**CRABBET PARK, OFFICE TO RESIDENTIAL**

**ADDITIONAL INFORMATION TO  
DISCHARGE PLANNING CONDITION 3**

**5033004-RDG-XX-XX-T-C-300002**

The purpose of this statement is to provide additional information to address the responses to discharge of Planning Condition 3 contained within further information request planning application DM/26/0846 dated 30<sup>th</sup> April 2026.

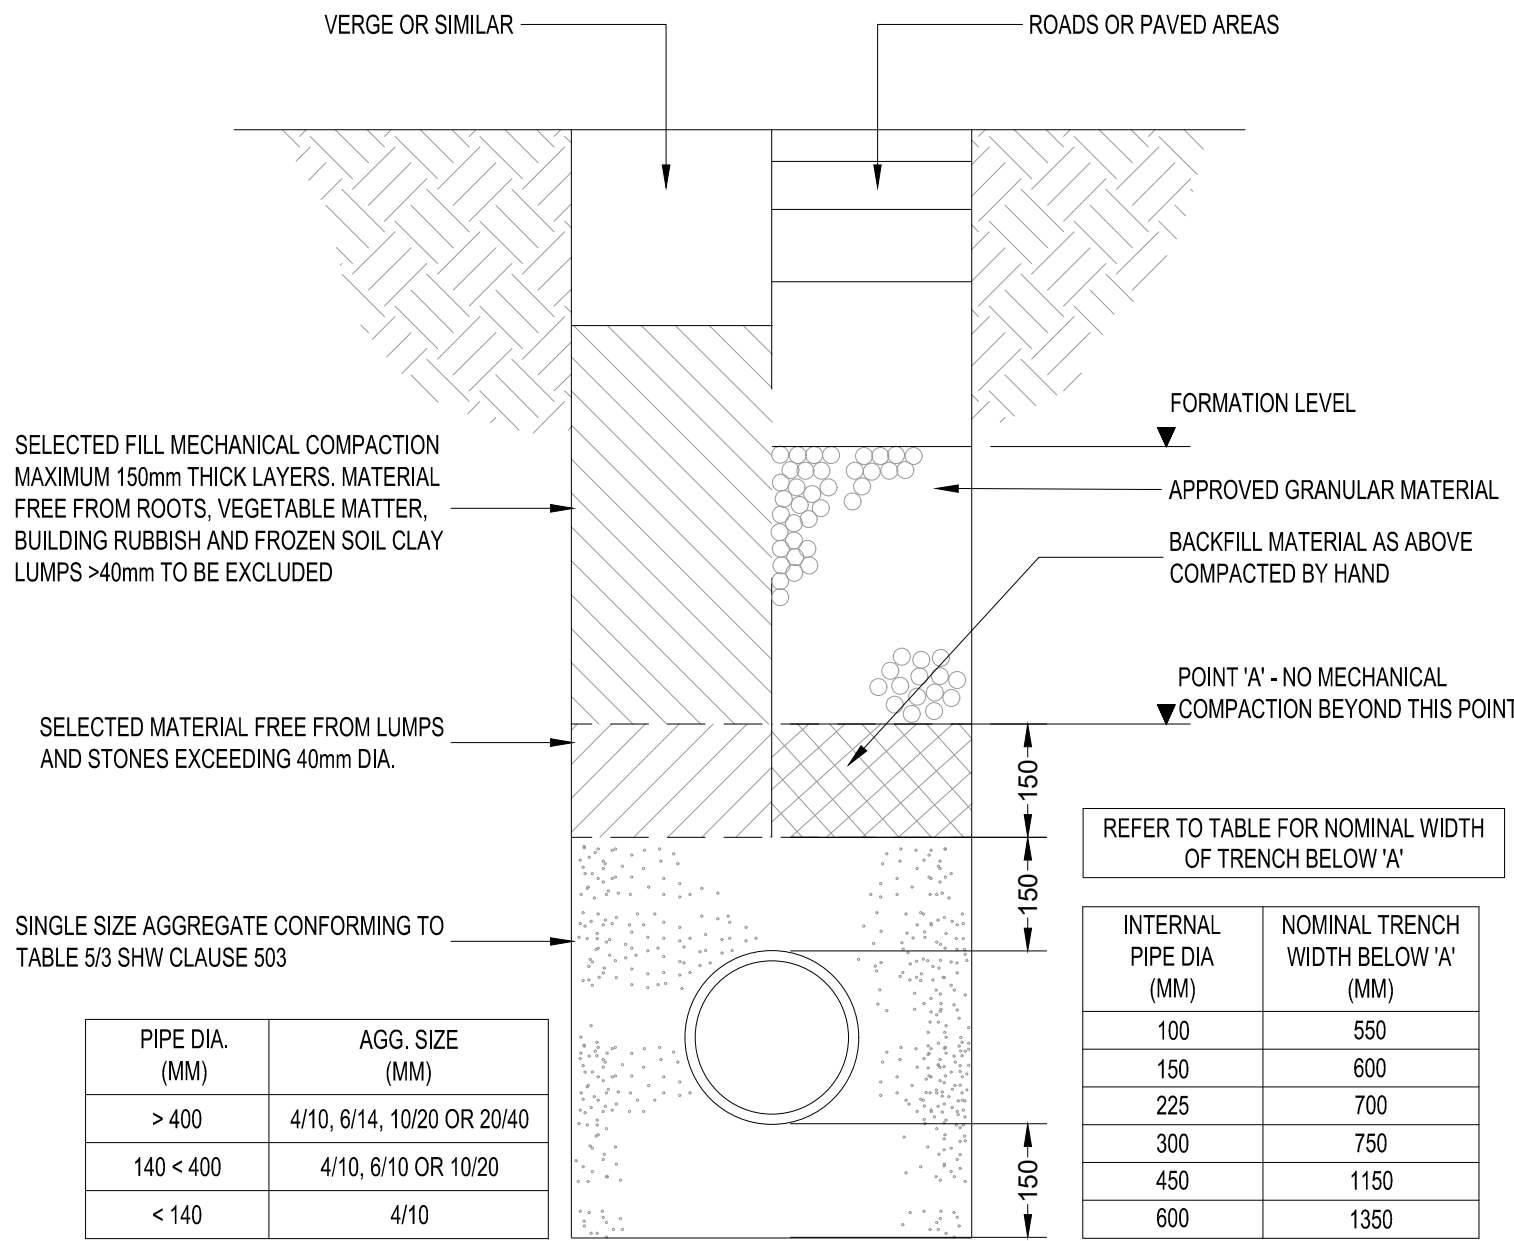
***3: Design exceedance flow routes should be clearly shown on the proposed drainage layout.***

Exceedance flow paths have been added onto the proposed drainage strategy drawing – refer to the below ground drainage strategy in **Appendix B**.

LINED FILTER TRENCH DRAIN DETAIL  
SCALE 1:10

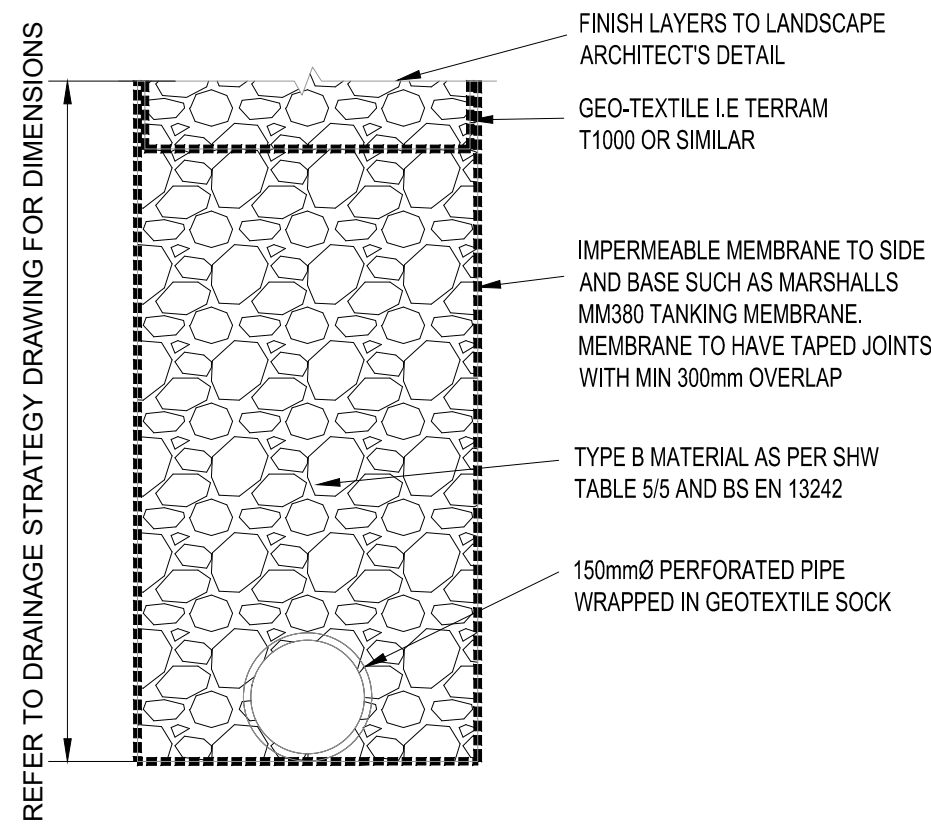
***6: Details should be provided to demonstrate that adequate water quality treatment is being achieved, in accordance with the CIRIA SuDS Manual.***

Proposed surface and foul water drainage details have been developed in line with the original design principles produced by Cannon Consulting Engineers dated in August 2025. The proposed SuDS features have been designed in accordance with CIRIA SuDS Manual and provide adequate levels of water quality treatment for the proposed development.
